Planning and Zoning Meeting Agenda
Wednesday, April 2, 2025 ~ 5:30 PM
New City Hall at East Campus
2818 E. U.S. Hwy. 290
Fredericksburg, Texas 78624

CAPTION: Request Z-2501: By Continental Homes of Texas, L.P. To Consider a Zoning Change Request from R5, Pation Home Residential to a Planned Unit Development (PUD) for Approximately 70 Acres Located Between West Live Oak and Pyka Rd Addressed as 256 Pyka Rd.

RE: Z-2501 – Review Comments for the creation of a PUD (Planned Unit Development) and Establishment of Zoning for Property Located at 256 Pyka Lane.

Response to Comments Z-2501 –PUD (Planned Unit Development) and Establishment of Zoning for Property Located at 256 Pyka Lane dated March 12, 2025.

**EXHIBIT A
LAND USE PLAN**

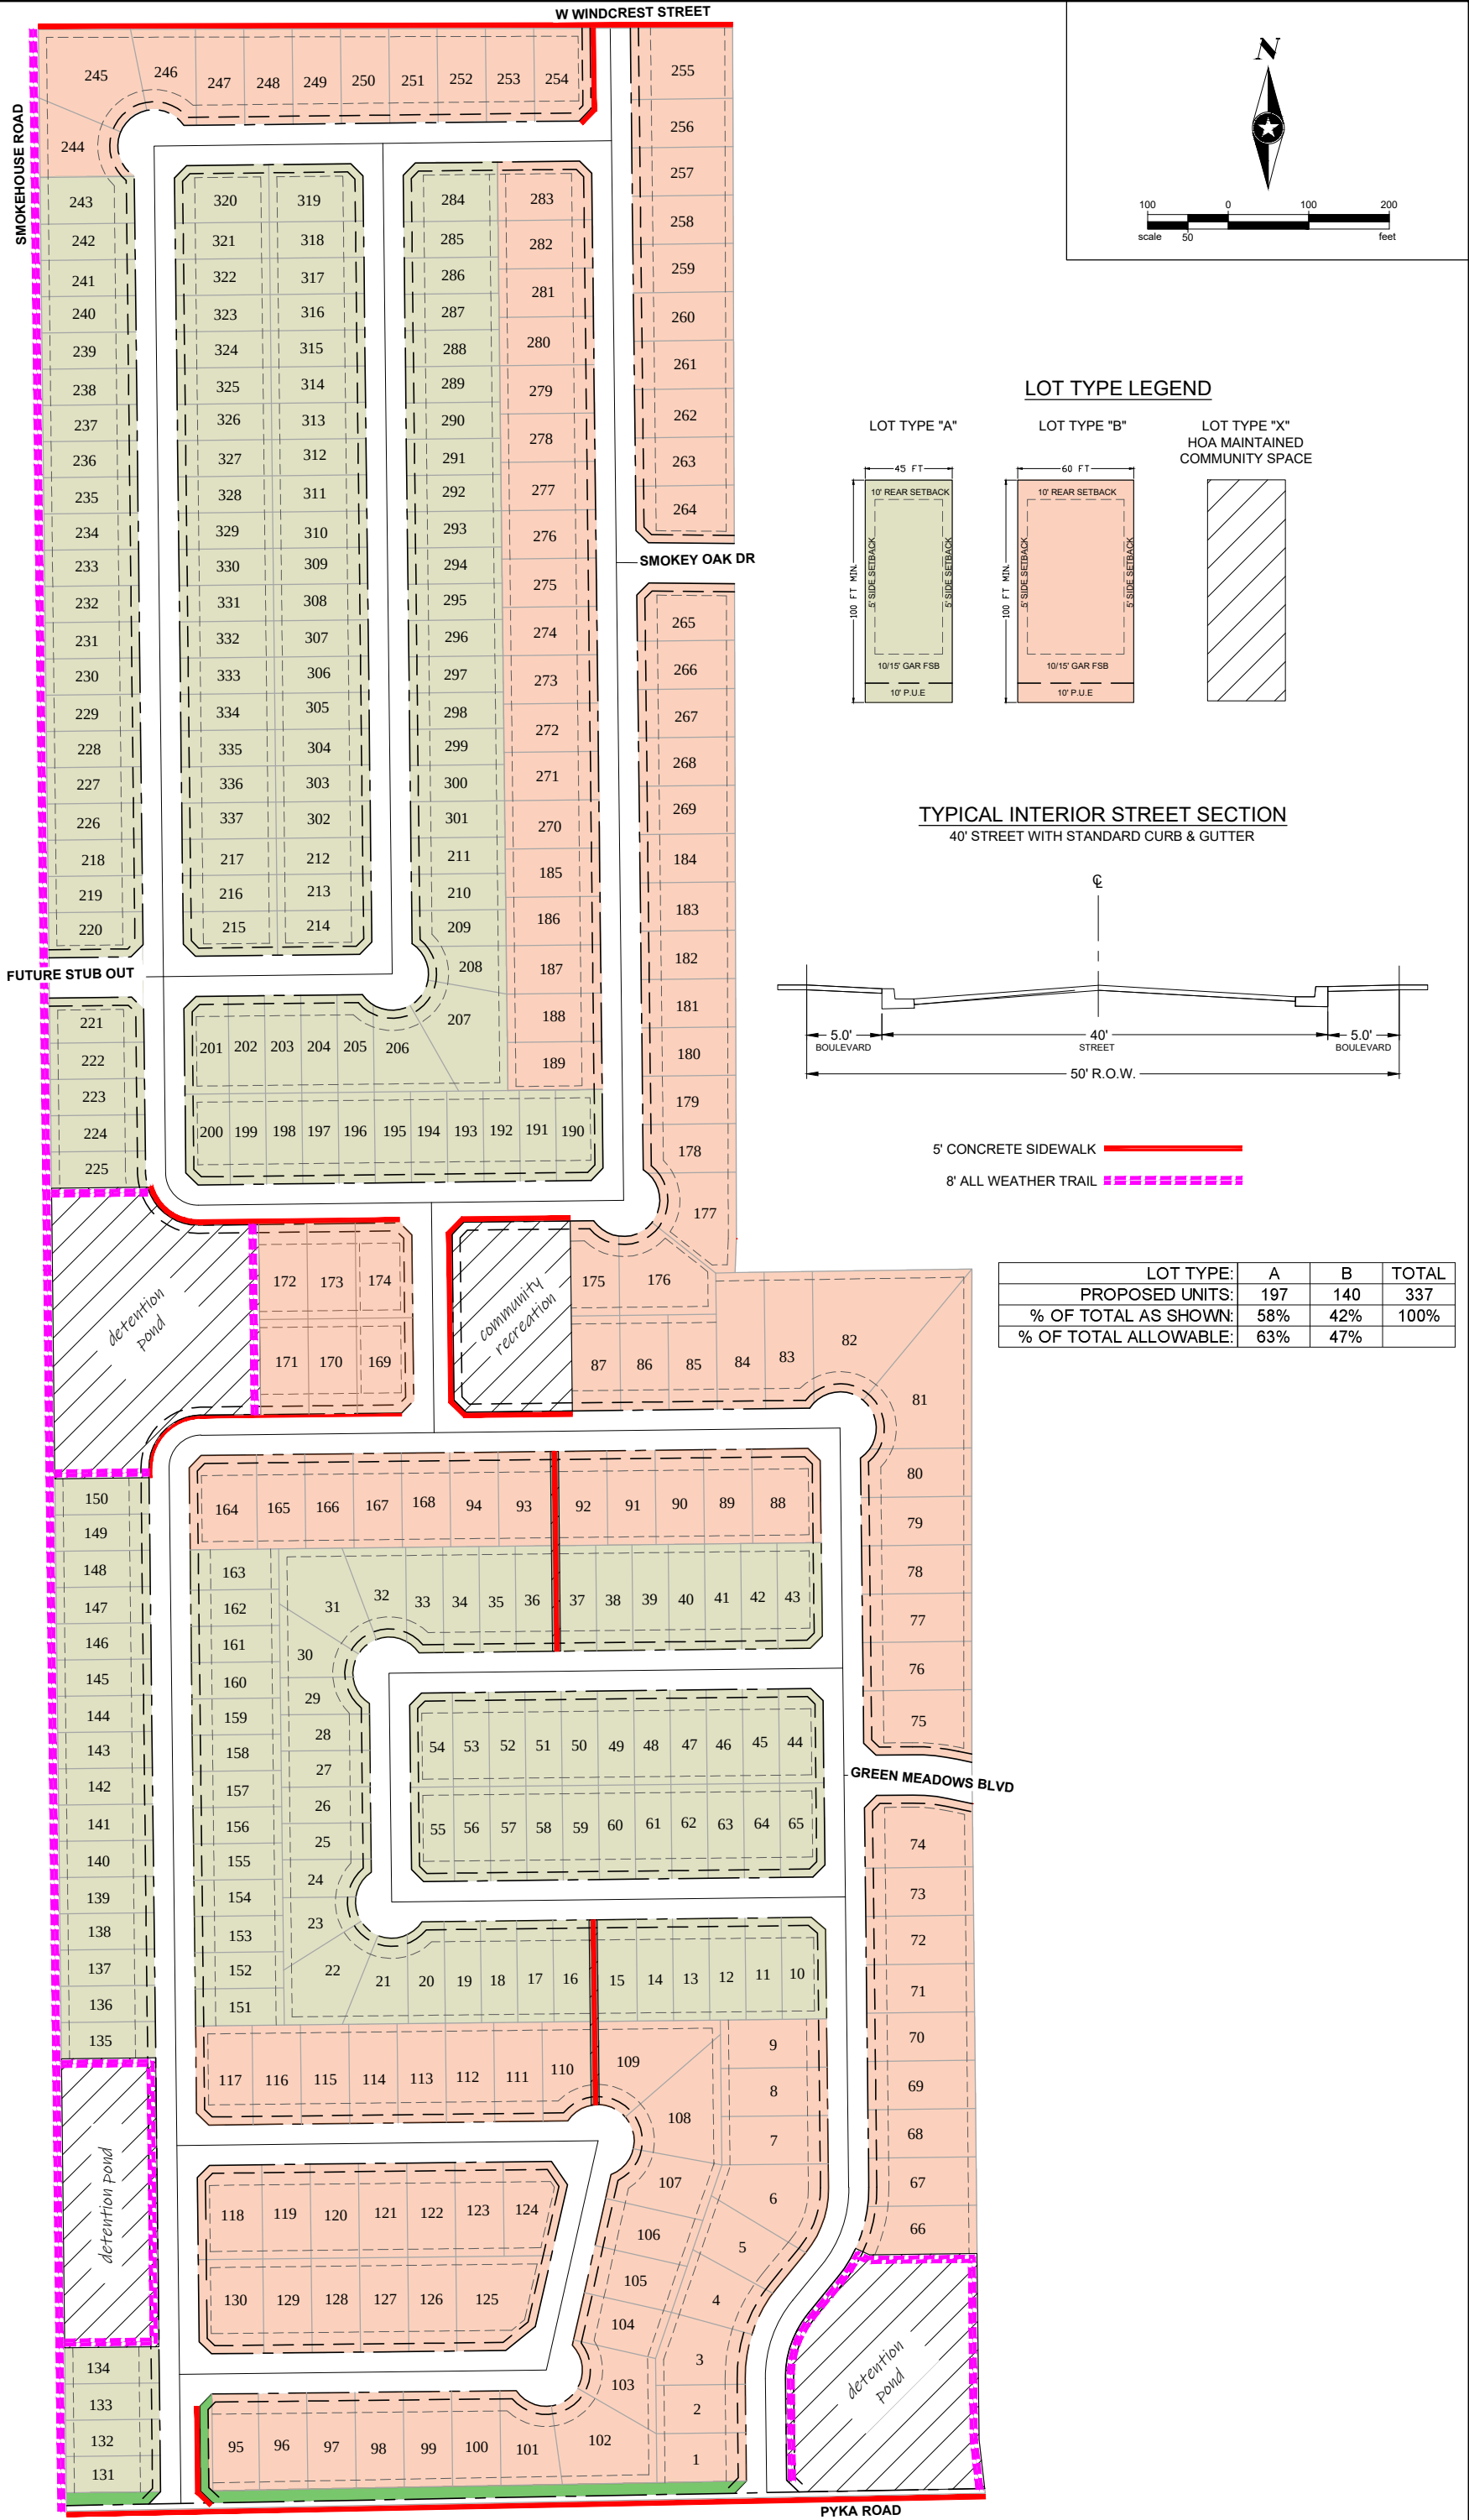
Please update exhibits A and B to address the following:

1. The construction of W. Windcrest shall be included phase 2 of the project and access provided to Windcrest from the development.
2. Please update the street cross section to show City Standard 40' wide pavement section for local streets.

3. Update conceptual land use plan to show a sidewalk/ trail plan for the subdivision.
4. All sidewalks shall be ADA compliant and constructed to City Standards. Sidewalks will be constructed on the south side of W. Windcrest and on the north side of Pyka Road, block cut-throughs to the north and south, and around the amenity site. Sidewalks will connect the amenity site to the trails.

Please see attached mark up on Exhibit A “proposed land plan” addressing sidewalk and trail locations.

2. Please update the street cross section to show City Standard 40' wide pavement section for local streets. **Acknowledged. Cross section will match local street sections and has been added to Exhibit A.**

3. Update conceptual land use plan to show a sidewalk/ trail plan for the subdivision. **Acknowledged and plan is updated.**
4. All sidewalks shall be ADA compliant and constructed to City Standards. Sidewalks will be constructed on the south side of W. Windcrest and on the north side of Pyka Road, block cut throughs to the north and south, and around the amenity site. Sidewalks will connect the amenity site to the trails. **Acknowledged and plan is updated.**

5. Trails should be shown around detention areas/green spaces where possible. A trail shall be constructed in Smokehouse Road right of way from W. Windcrest to Pyka Road. Trails shall be constructed of a stabilized all-weather surface resistant to erosion, muddy wet conditions, or dusty dry conditions. Trails around detention ponds should be at least 5 feet wide where possible. The trail in the Smokehouse Road right of way should be minimum 7 feet wide where possible. **Acknowledged and plan is updated.**

6. Please see attached mark up on Exhibit A “proposed land plan” addressing sidewalk and trail locations. **Acknowledged and plan is updated.**
